**TOWN OF BAY HARBOR ISLANDS  
MORRIS N. BROAD COMMUNITY CENTER  
1175 95TH STREET  
BAY HARBOR ISLANDS, FL 33154**

**DESIGN REVIEW BOARD**

**November 12, 2024  
7:00 PM**

1. Request for approval for an exterior renovation for “Shani Kagan & Beaujon Davidson” located at 1231 101 Street, Lot 15 of Block 25. On April 16, 2024, June 17, 2024, and October 1, 2024, the Board deferred the project. The owners have submitted the revised plans. The resubmittal package meets minimum code requirements and appears to include the information requested by the DRB. The owners are proposing to renovate the existing exterior house facade with a raised front entry & foyer / wood-appearing stucco siding and new doors and window locations. Enclosed please find the site plan, narrative and elevations. Item #1.

**A2**

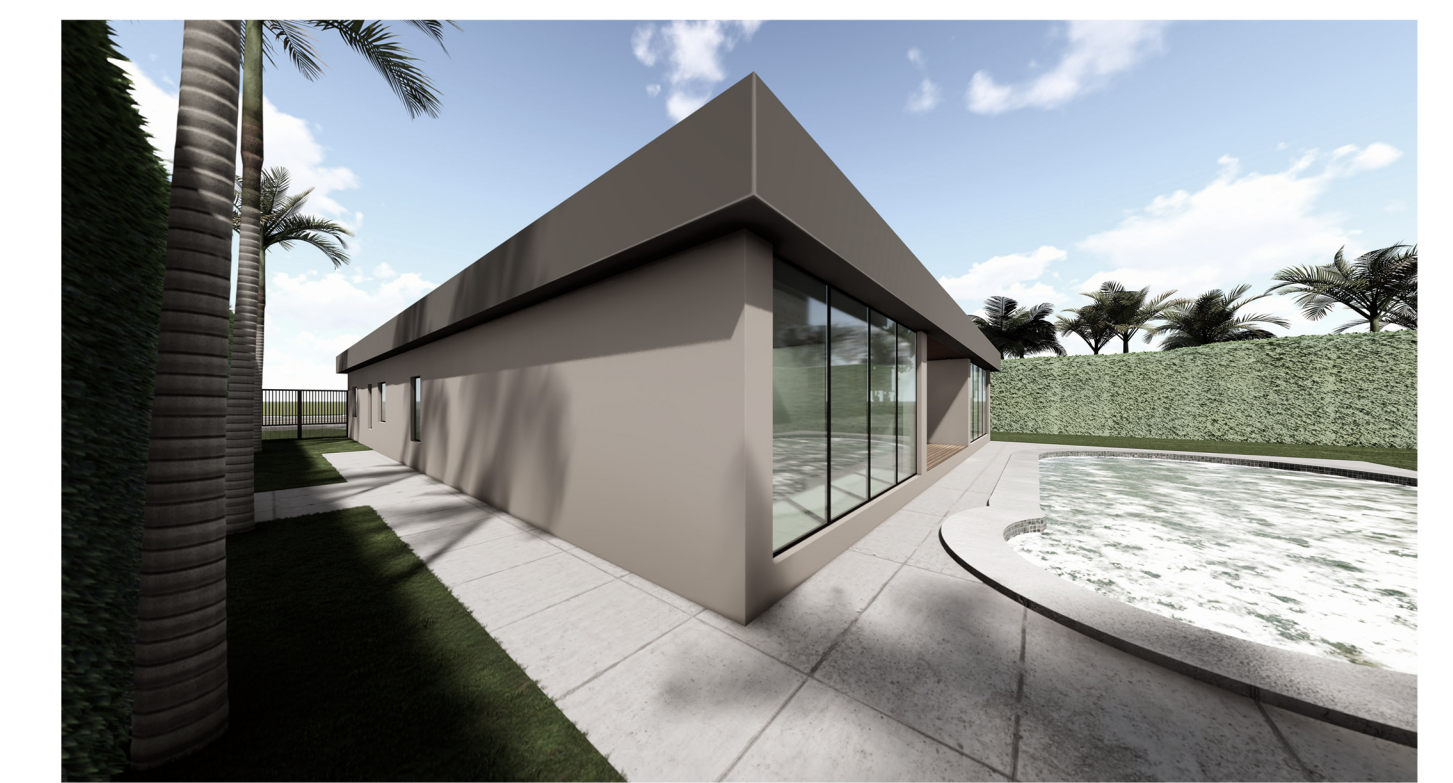
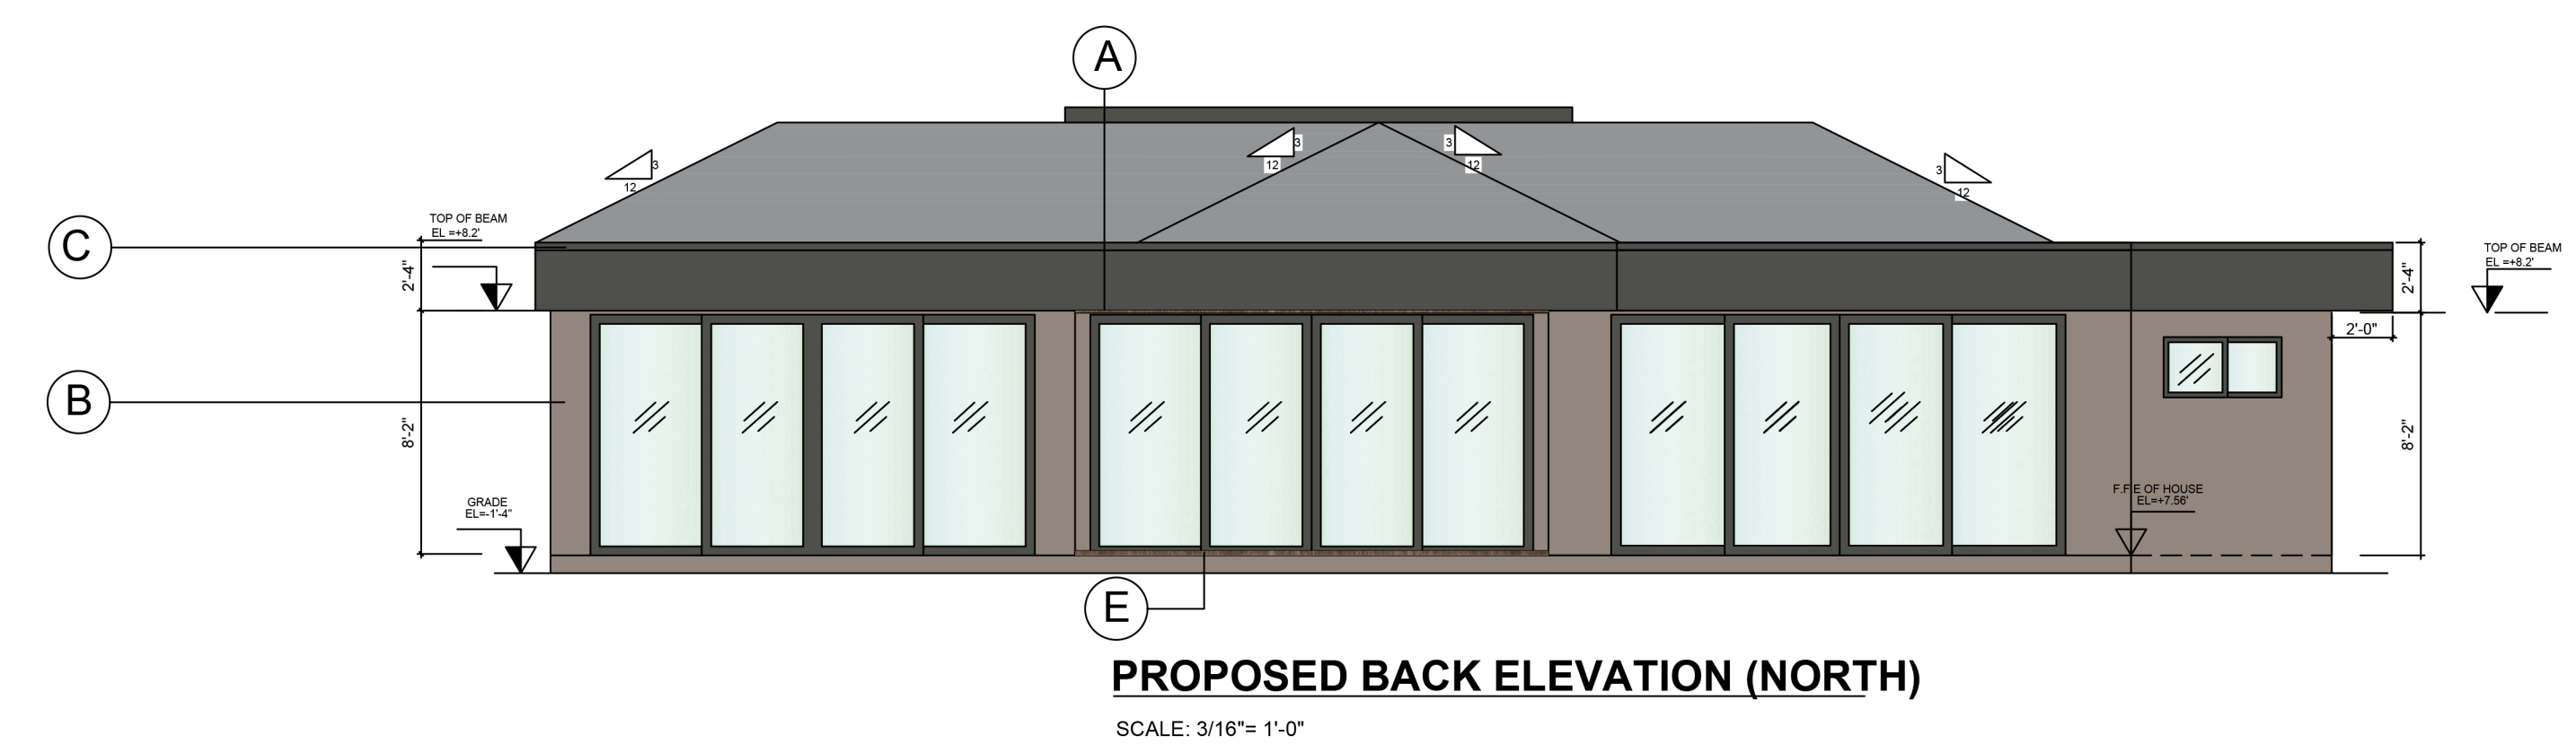
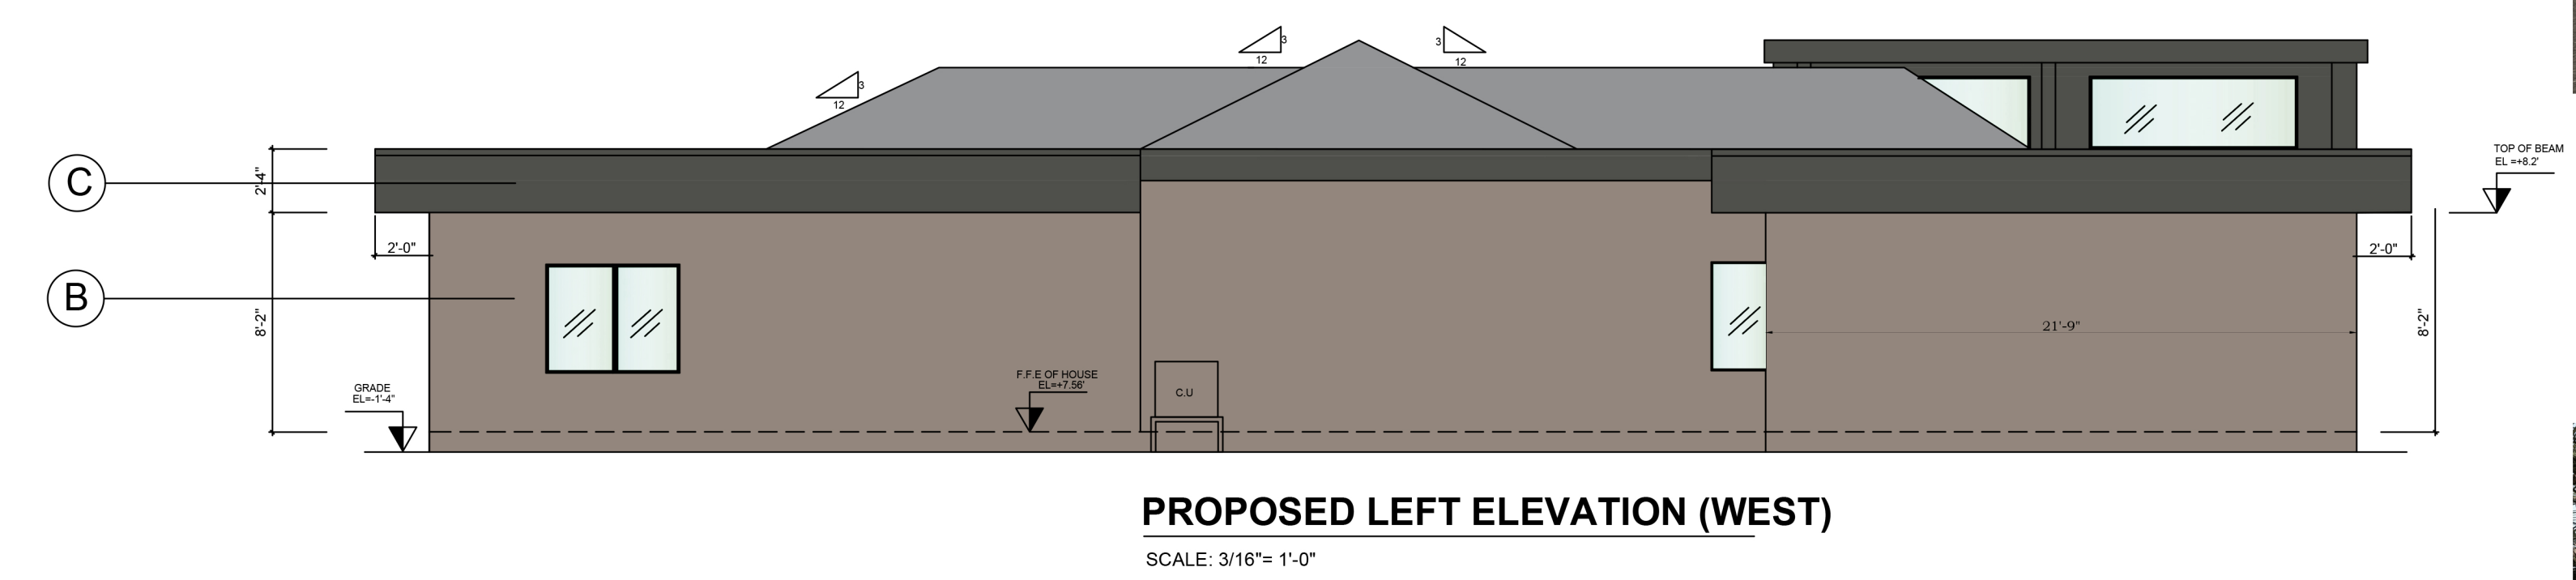
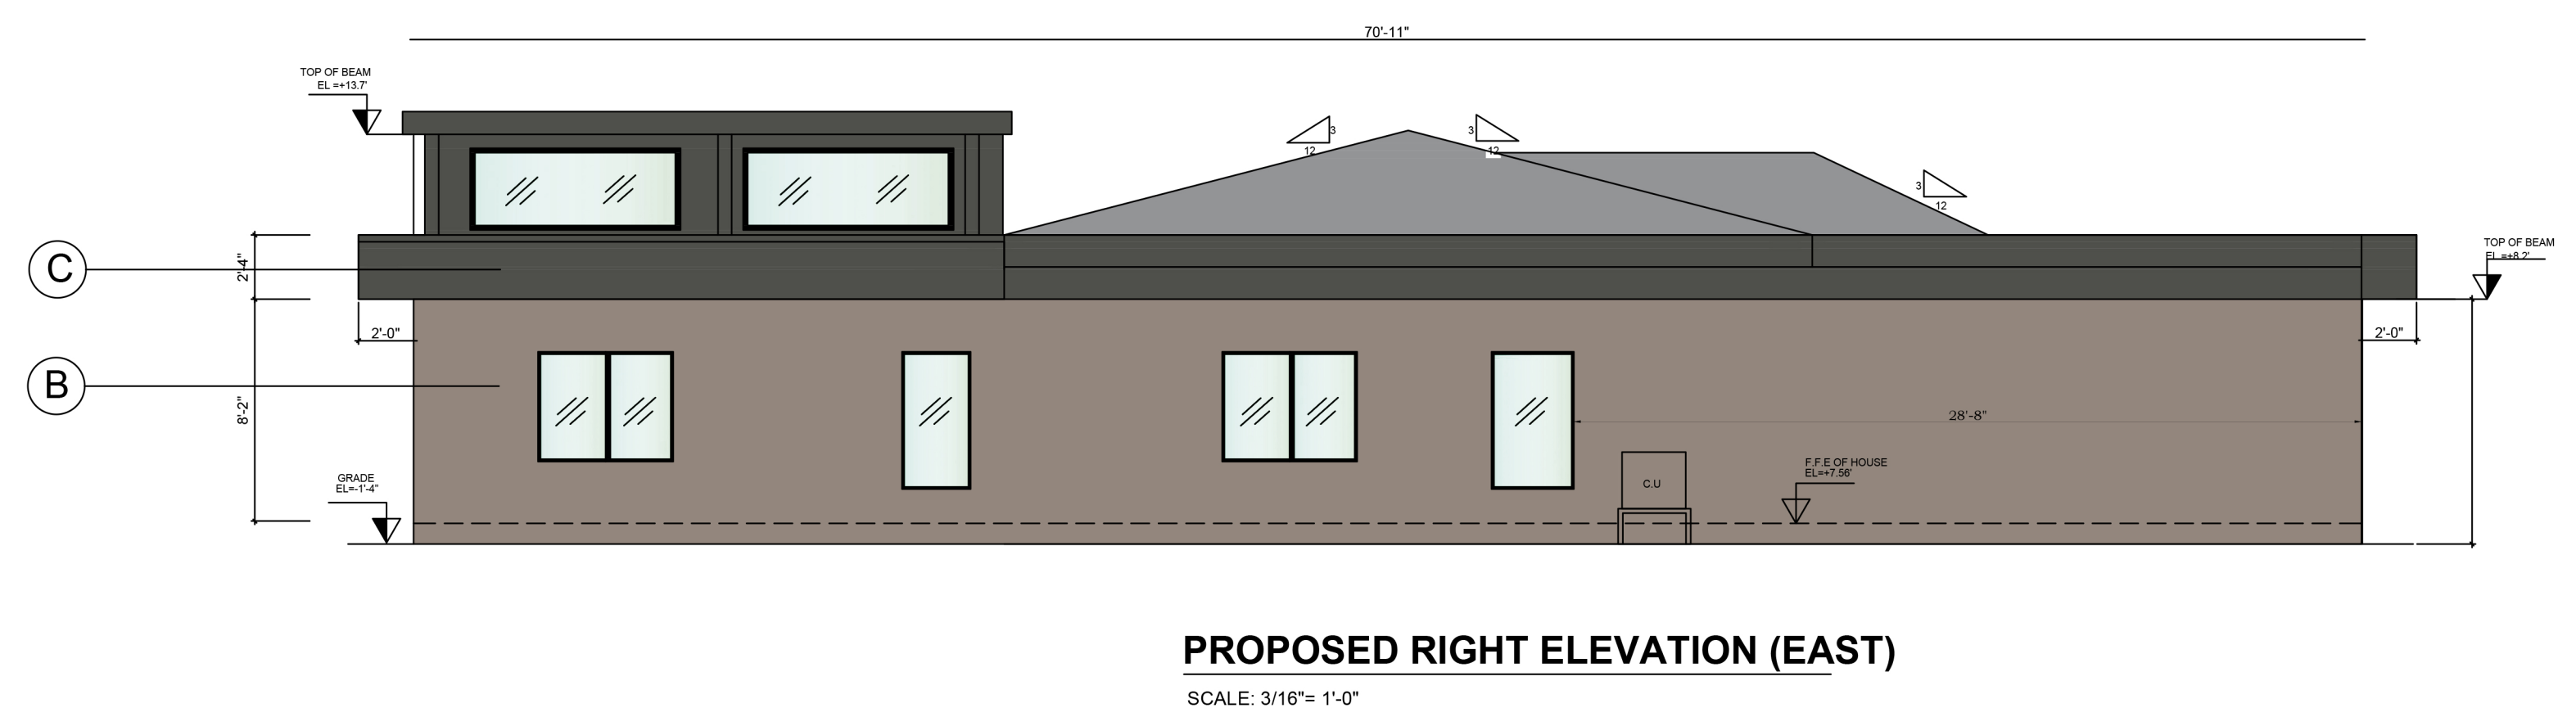
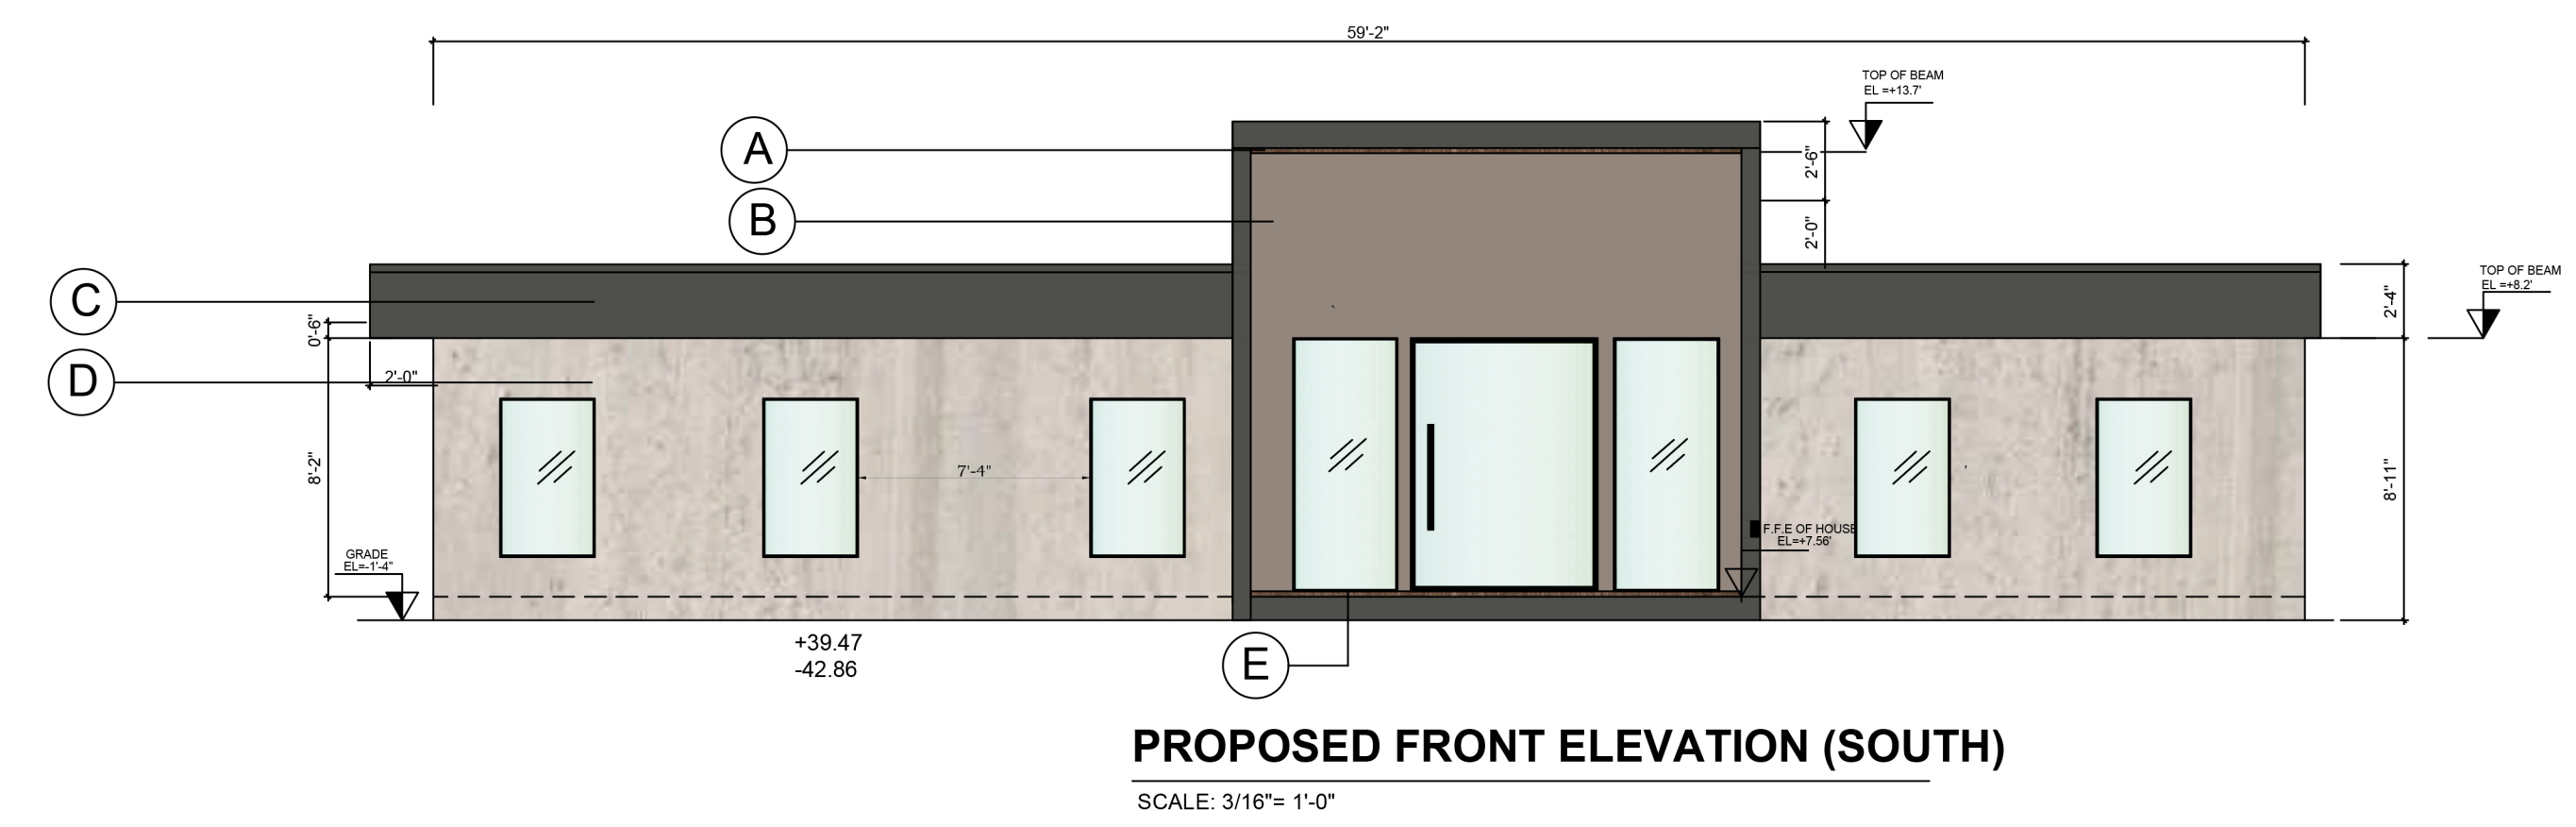
Board Member Feldman pointed out the window schedule on Page A2 of the plans, which seems like there would be an aluminum glass fixed window. It does seem like all the windows will be the same as per the window schedule.
